# Intel<sup>®</sup> 82576EB Gigabit Ethernet Controller Specification Update

Revision 2.84  
January 2012

Figure 1. Example With Identifying Marks

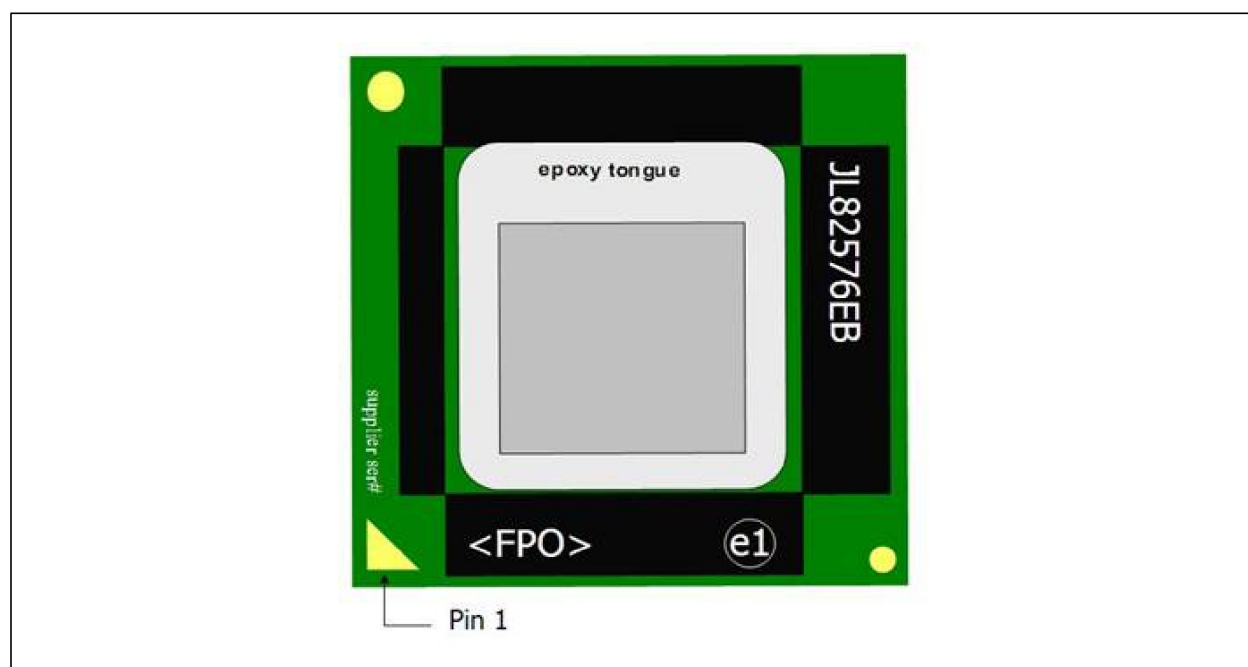
Lead-free parts will have "JL" as the prefix for the product code (vs. "HL").

The devices can also have a "GB" marking, instead of "EB". These are functionally equivalent and only used on Intel network interface adapters.

There is an internal designator visible as a dash on the die side of some packages. It's location may differ. The mark (looks like a dash, approximately 300X1000 µm in size) does not impact function.
